METROPOLITAN GOVERNMENT OF NASHVILLE AND DAVIDSON COUNTY

Metropolitan Historic Zoning Commission
Sunnyside in Sevier Park
3000 Granny White Pike
Nashville, Tennessee 37204
Telephone: (615) 862-7970
Fax: (615) 862-7974

STAFF RECOMMENDATION 1902 Russell Street September 19, 2012

Application: New construction – infill and accessory building
District: Lockeland Springs-East End Neighborhood Conservation Zoning Overlay
Council District: 06
Map and Parcel Number: 08314015500
Applicant: Jamie Pfeffer, Architect
Project Lead: Sean Alexander, sean.alexander@nashville.gov

3 SITE PLAN
 SCALE 1" = 40'

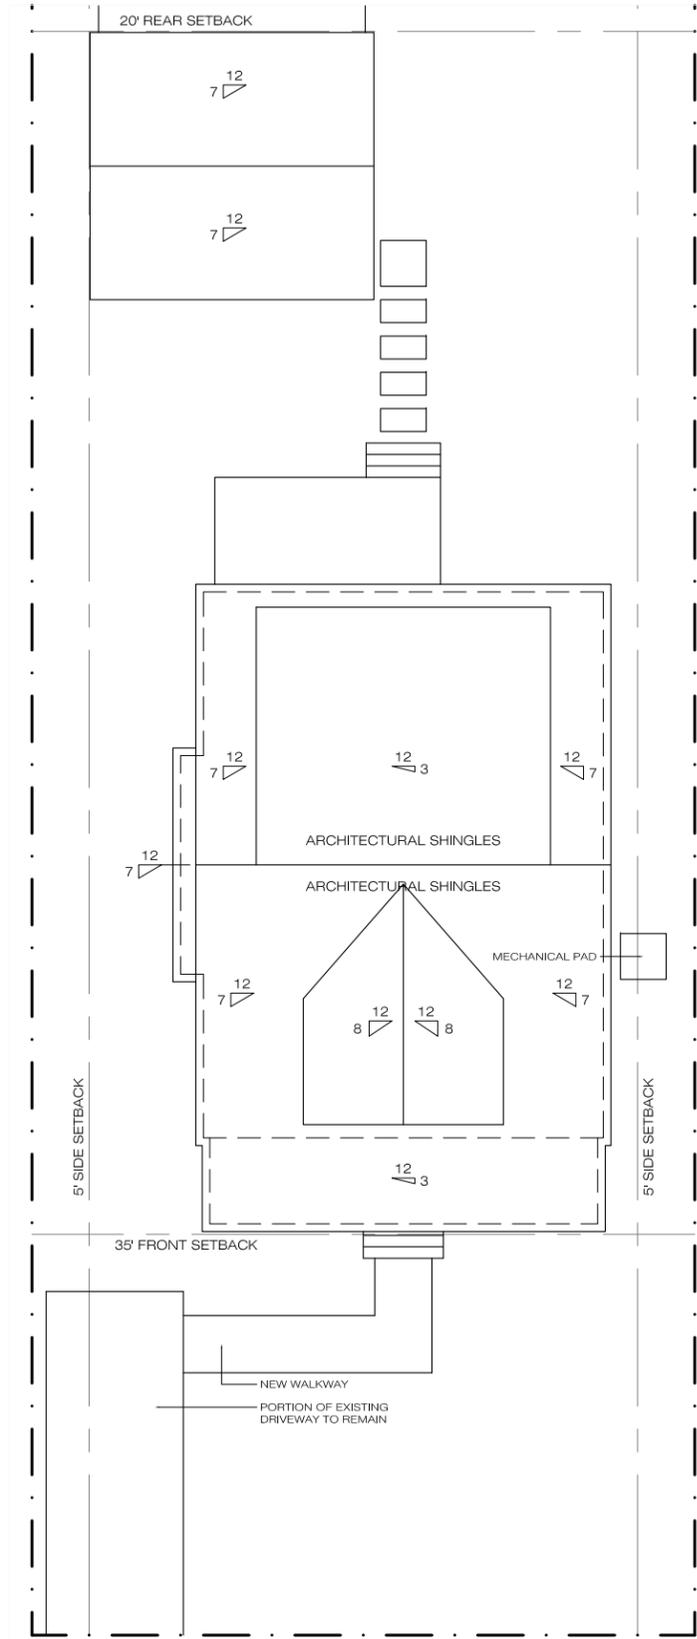
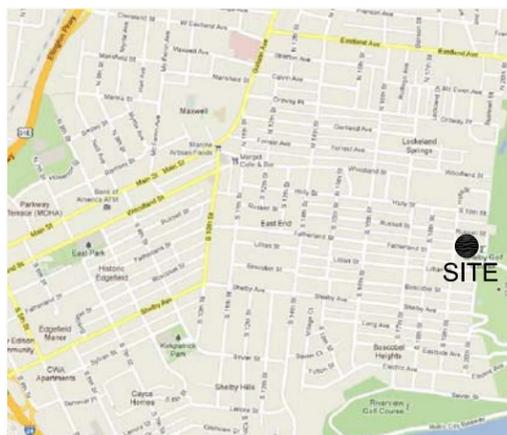
1. The driveway shall either be removed entirely or retained from the midpoint of the structure to the street;
2. The concrete walkway shall be extended to address the street; and,
3. Staff provide final approval of windows and doors prior to purchase.

The new primary building will keep a concrete walkway in front that connects to an existing driveway that is to be partially removed, leaving a paved section for parking at the front of the property. The accessory building will be accessed from the alley, as were historic accessory structures. Because the driveway is not needed to access the garage and front yard parking is not typical of the area, it would be more appropriate and in keeping with guideline II.B.9 to either remove the driveway entirely or, because it is existing, keep it at least to the midpoint of the structure to the street. The concrete walkway should also be extended to address the street.

1 FRONT ELEVATION
SCALE 1/8" = 1'-0"

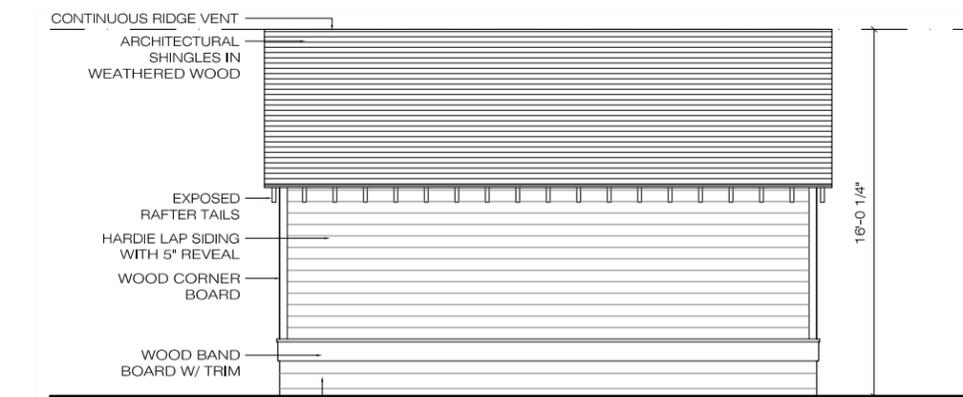
The primary roof of the new building will be a side-facing gable with a 7:12 pitch. There will be a gabled dormer centered on the front slope of the roof with an 8:12 pitch and a shed-roofed dormer on the rear with a 3:12 pitch. These roofs are compatible with those of surrounding historic houses and meet guideline II.B.5.

The front facade of the new building will have three evenly spaced bays. The right elevation will also have three evenly spaced window bays, and the left elevation will have two evenly spaced window bays. At the rear of the left elevation there will be a twenty-foot (20') section of wall without openings. Because this is at the rear, it will not contrast greatly with the surrounding context. The majority of windows will be approximately twice their width in height. The proportion and rhythm of windows is compatible with surrounding historic houses and meets guideline II.B.7.
